Subject: **THIRD RESPONSE TO PEER REVIEW**
Phase 2 of Tentative Tract 37-46
White Mountain Estates Subdivision
Chalfant Valley, Mono County, California

Reference: Review of Revised Site Geologic Map
Phase 2 of Tentative Tract Map No. 37-46
White Mountain Estates Subdivision
Chalfant Valley, Mono County, California
Prepared by AMEC Earth & Environmental dated June 13, 2006

GEOLOGIC LOG OF TRENCH T-11
SHEETS 1 – 5 OF 5

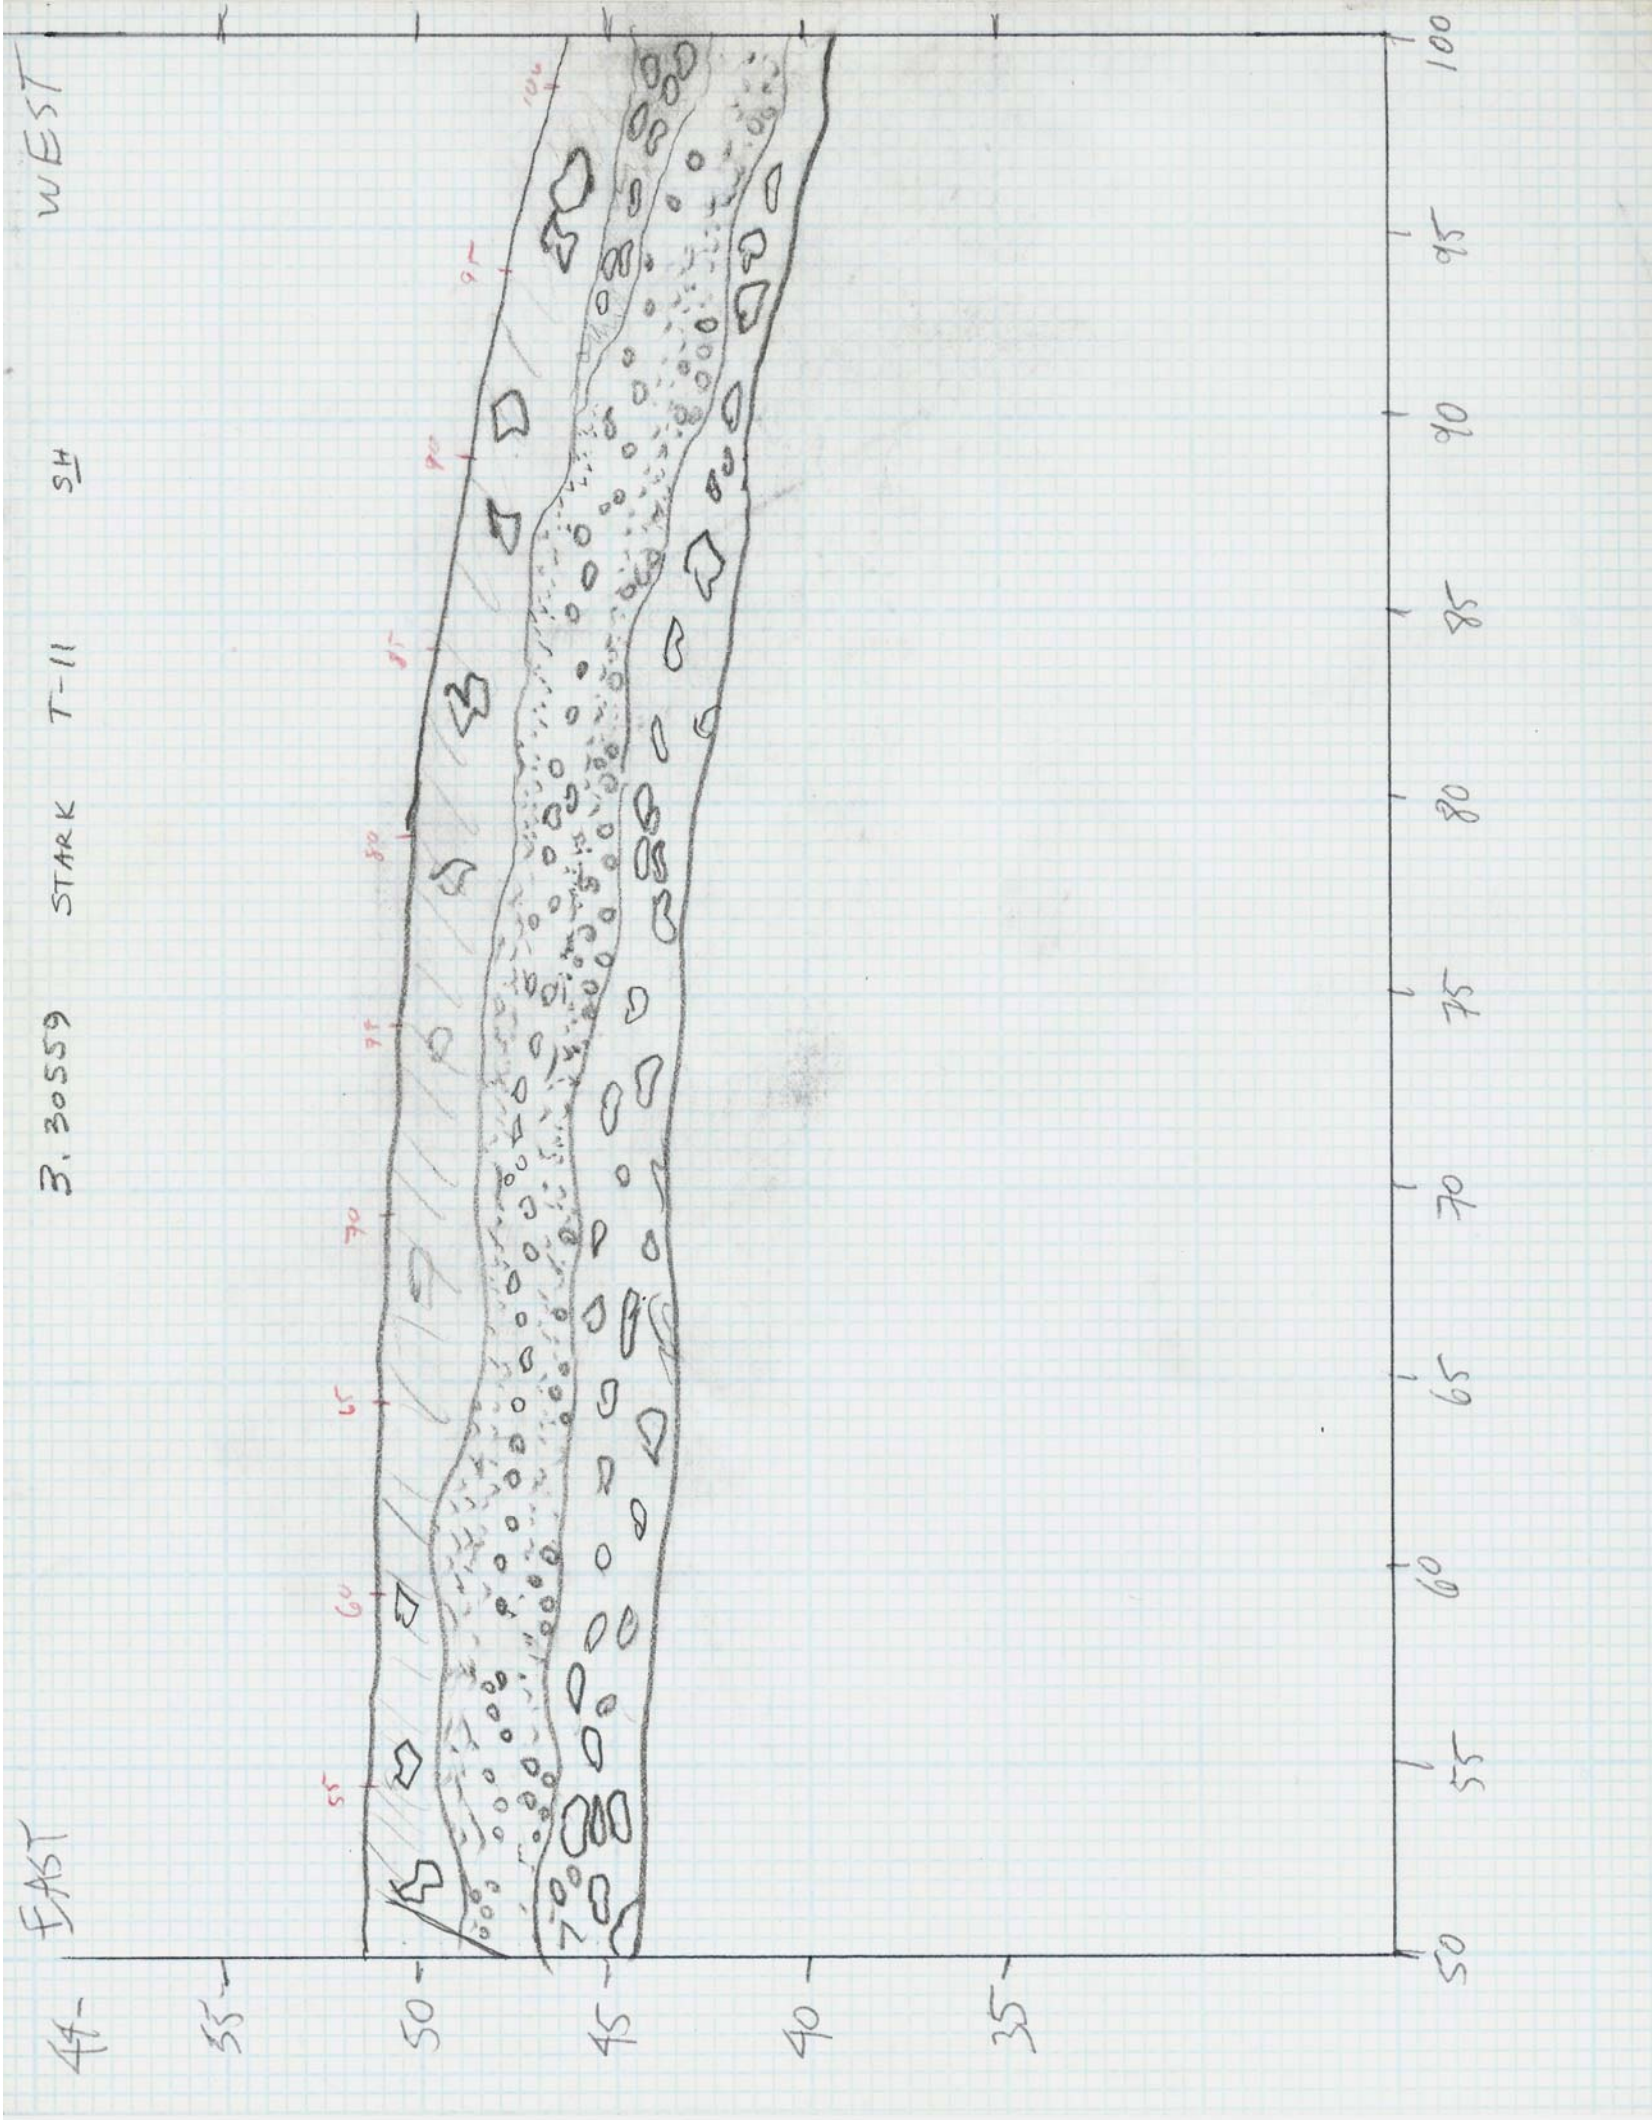
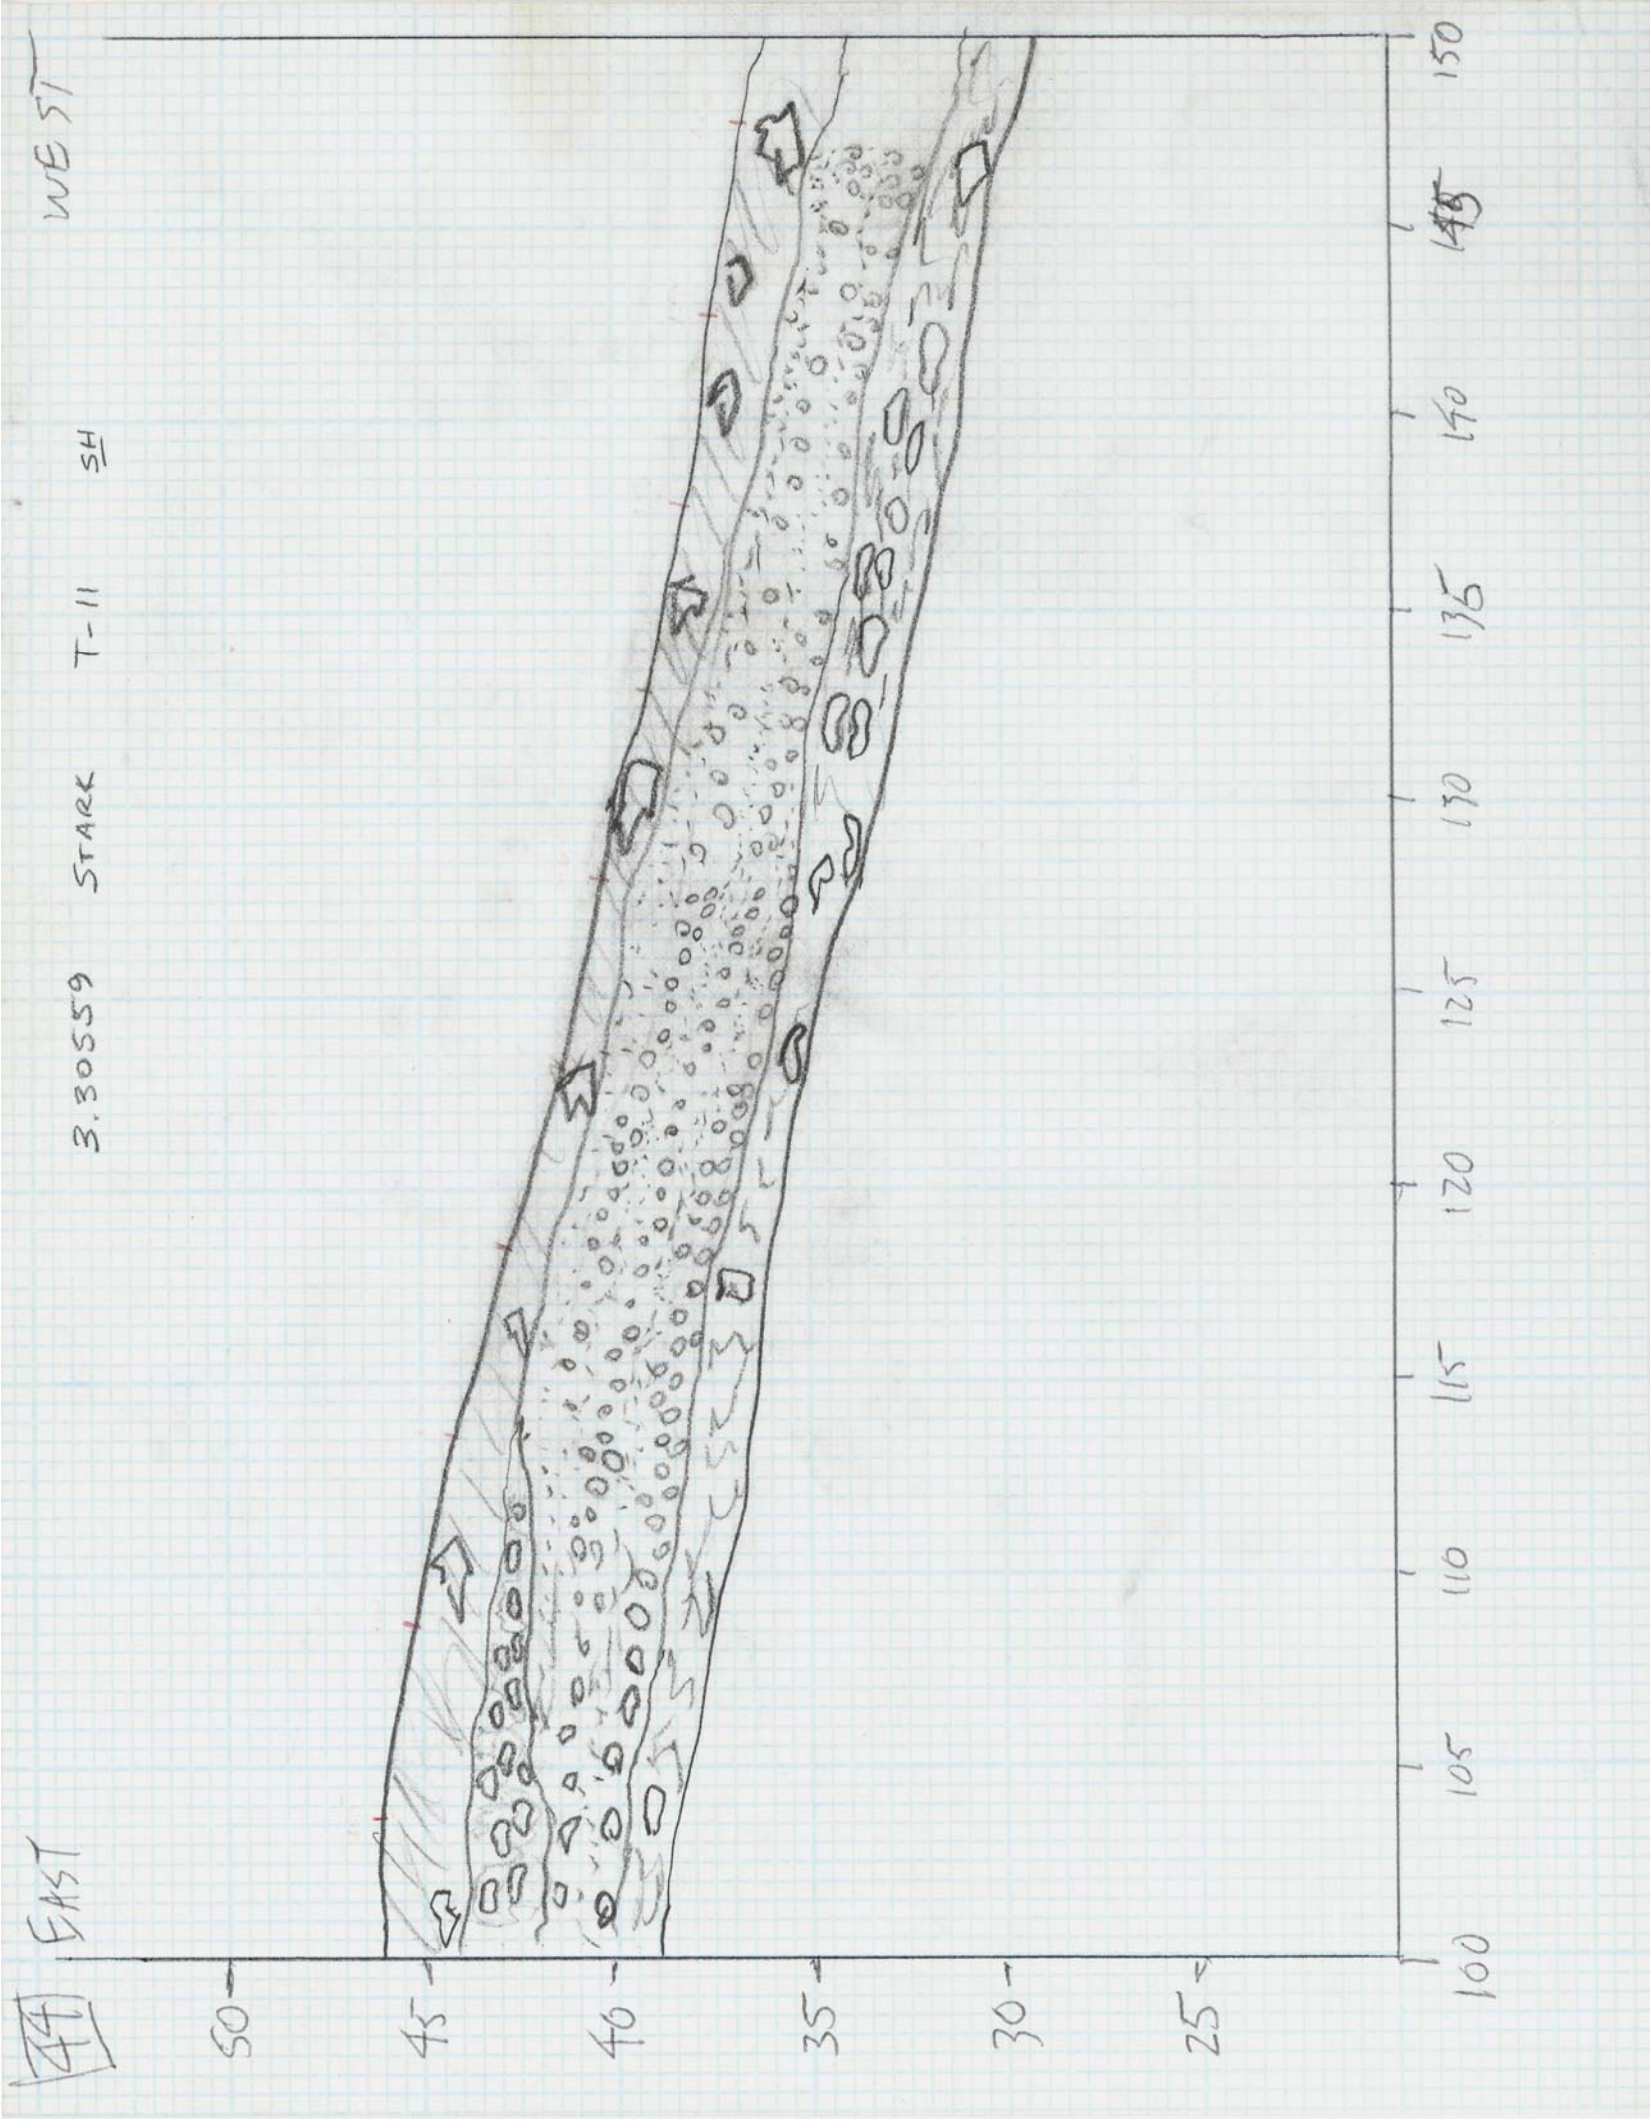
Due to the uncertainty associated with the location or projection of active fault features from the existing exploratory fault trenches it is recommended that Minimum building areas be established for each lot within the existing habitable zones. Building areas that can be established immediately adjacent the existing fault trench excavations are approved with respect to active faulting based on the existing data. Proposed building areas that are more than 50 feet from an existing fault trench will require additional subsurface fault trenching to establish that the building area is free of active faulting. The location of any proposed additional fault trenches, to substantiate the validity of a proposed building area, should be reviewed and approved by the geotechnical consultant for Mono County prior to excavation and logging. The designation of acceptable building areas, verified by the existing fault trench data or new fault data as discussed above, should be accomplished prior to Mono County's approval of the tract.

Response: Two additional fault trenches were proposed and located upon approval via telephone and email from the geotechnical consultant (AMEC) for Mono County. Each trench was located to provide additional data within those habitable areas that had been previously established by rather lengthy projections. Additional Fault Trench T-11 was excavated and logged across the habitable zone that traverses proposed Lot 43, and additional Fault Trench T-12 was excavated and logged across the habitable zone that traverses proposed Lot 41. Each trench exposed faulting OUTSIDE of each habitable

zone as was anticipated from our previous findings. Faulting was NOT observed within either habitable zone on either lot. Therefore, we have revised each habitable zone to reflect these findings, and they are shown on the attached Revised Site Geologic Map. Based on the dimensions of the largest footprint of the manufactured homes that are proposed for the subject site, Minimum Building Areas (MBA) have also been established for each lot within each revised habitable zone. It should be noted that each MBA location is provided to demonstrate fit and buildability within the habitable zone only; they are not intended to restrict structures to that location or dimension. The west side of the habitable zone across Lots 40 and 42 has been revised such it is now setback fifty feet from the nearest mapped fault to the west, and as a result the MBA on Lot 42 has been repositioned inside the habitable zone such that there is still adequate room for a habitable structure. Additionally, the habitable zone has been removed from proposed Lot B Common Area for Phase 1 of Tentative Tract 37-46 since the proposed water storage tank and propane tanks are not habitable structures; however, their proposed locations have been plotted such that they are as far away as possible from the nearest mapped faulting on this lot in order to minimize the potential for disruption or damage to the tanks from future ground surface rupture-causing events.
